PSEG
Nuclear LLC

LRN-01-0412
LCR S01-08

**EXIGENT REQUEST FOR CHANGE TO TECHNICAL SPECIFICATION 3/4.7.4
SERVICE WATER SYSTEM
SALEM GENERATING STATION UNIT NO. 1
FACILITY OPERATING LICENSE DPR-70
DOCKET NOS. 50-272**

SALEM GENERATING STATION
UNIT NO 1
DOCKET NOS. 50-272
CHANGE TO TECHNICAL SPECIFICATIONS

FIGURE 1
SALEM UNIT 1 SERVICE WATER SYSTEM

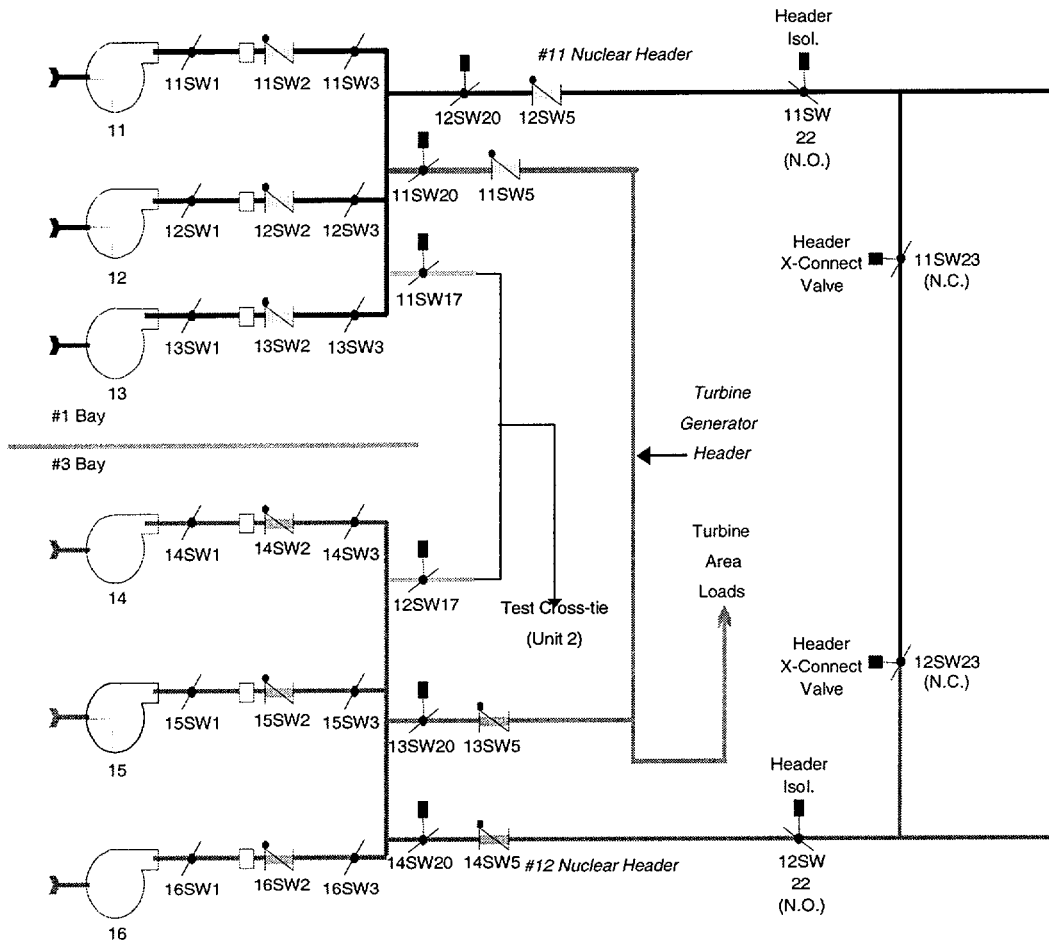
On Friday morning, November 30, 2001, Operations personnel noted water rising up through the gravel in front of the Service Water intake structure. The water was located approximately five feet from the structure and seven feet from the north side stairs, the 12 Service Water nuclear header is located below the location where the water was observed and was considered to be a likely source of the leak.

Subsequent investigation and troubleshooting determined that the leak is associated with the 12 Service Water nuclear supply header. This determination was partially based on the use of a dye test. Based on the information currently available, the leak is postulated to be at an underground mechanical joint or mechanical connection associated with the buried portion of the 12 Service Water nuclear supply header located near the Service Water structure. A simplified diagram of the service water system is provided in Figure 1.

To perform the selected repair method, the buried portion of the 12 service water nuclear header will be isolated such that all six service water pumps will be available and capable of supplying cooling water to the safety related equipment via the redundant nuclear header (number 11 header). In this configuration, the UFSAR assumption that two pumps per bay, and at least one powered from each vital bus, are available to mitigate the consequences of a Loss-of-Coolant Accident with a loss of power is maintained. To isolate the leaking section of the buried portion of the 12 nuclear header, the number 3 service water intake bay will be isolated temporarily to permit installation of a blind flange. The total period of time during which the number 3 bay is isolated will be limited to less than the 72 hours currently permitted by TS 3/4.7.4.

During the repair to the 12 nuclear service water header, the header will be isolated such that all six service water pumps will be available and capable of supplying cooling water to the safety related equipment via the redundant nuclear header (number 11 header). To isolate the leaking section of the 12 nuclear header, the number 3 service water intake bay will be isolated temporarily to permit installation of a blind flange. The total period of time during which the number 3 bay is isolated will be limited to less than the 72 hours currently permitted by TS 3/4.7.4.
